HISTORIC PRESERVATION COMMISSION

Date: January 11, 2024

SUBJECT: Historic Area Work Permit # 1051101 - HVAC Condenser

The Montgomery County Historic Preservation Commission (HPC) has reviewed the attached application for a Historic Area Work Permit (HAWP). This application was **Approved** at the January 10, 2024, HPC meeting.

LOCATION DRAWING
 LOT 2, BLOCK 79
 TAKOMA PARK LOAN & TRUST
 COMPANY'S ADDITION TO
 TAKOMA PARK
 MONTGOMERY COUNTY, MARYLAND

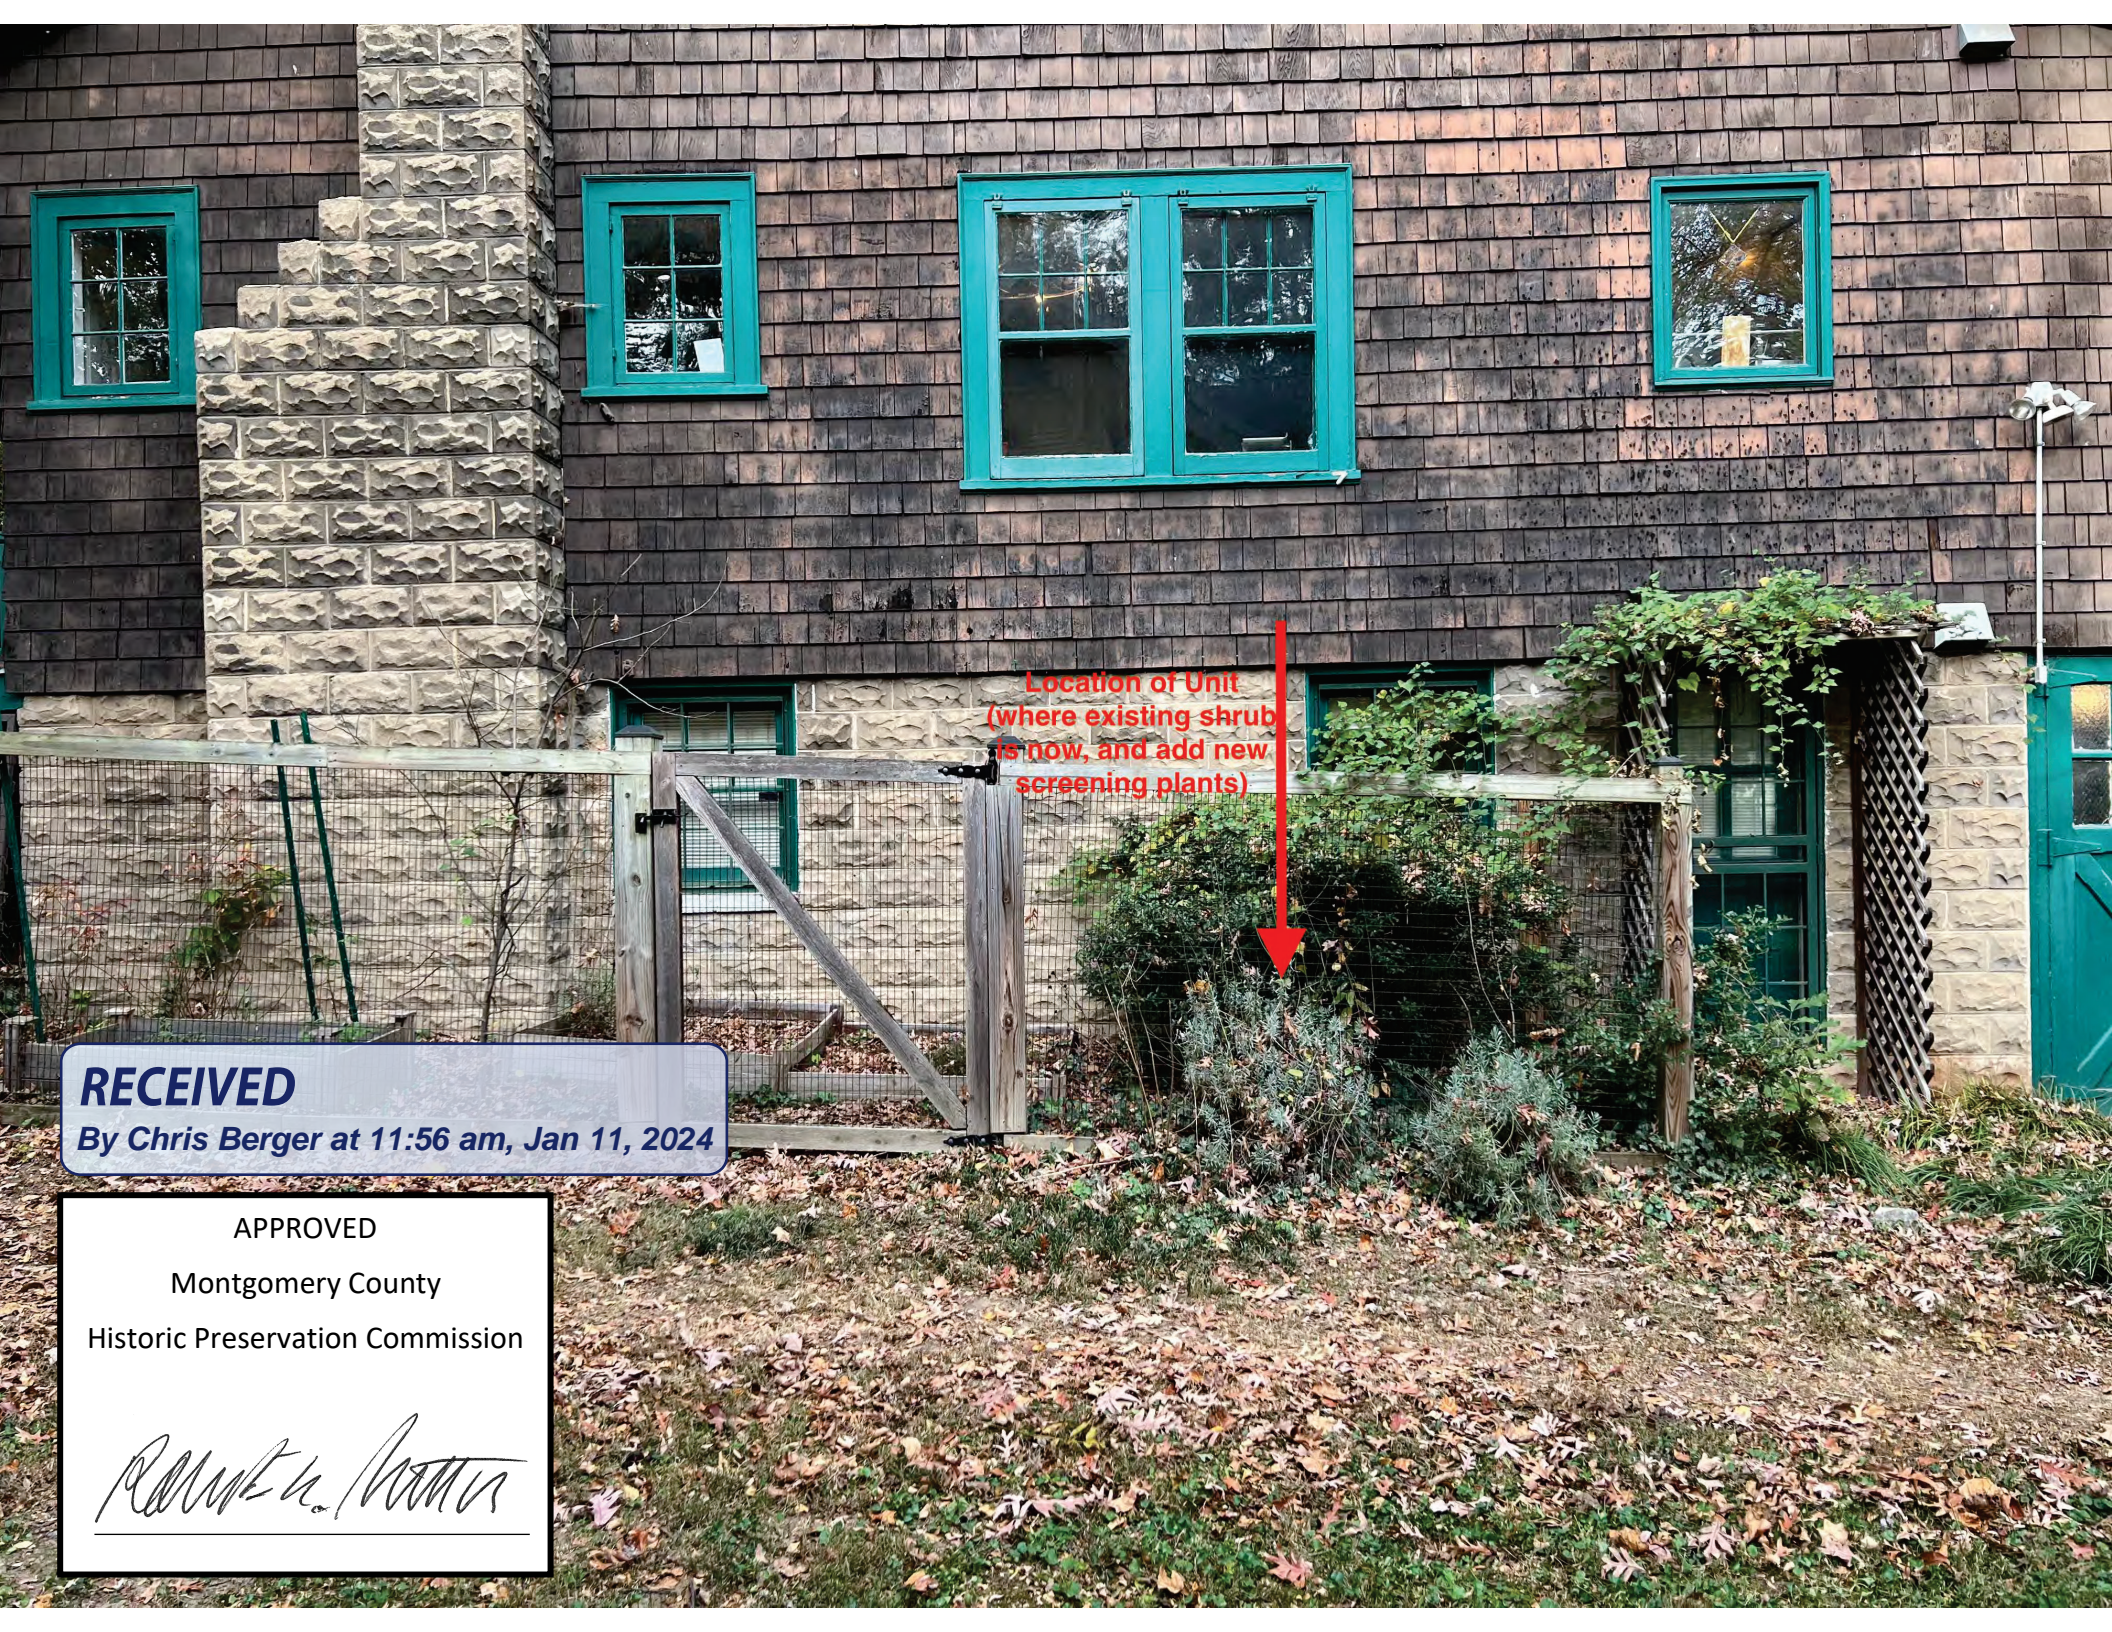
= Location of Outdoor Unit

Location of Unit
(where existing shrub
is now, and add new
screening plants)

Compressor unit dimensions are:

Height - 31 11/32 inches
Width - 37 13/32 inches
Depth - 16 13/32 inches

The pad dimensions will be approximately 18 by 38 inches.

The pad material will be black plastic.

It will be placed 18 inches from the foundation.

Re the fence extenders - as noted on the updated plat the north boundary section has 6 feet high chain link plus 26 inch high extenders from top of chain link, made from black plastic mesh with metal poles.
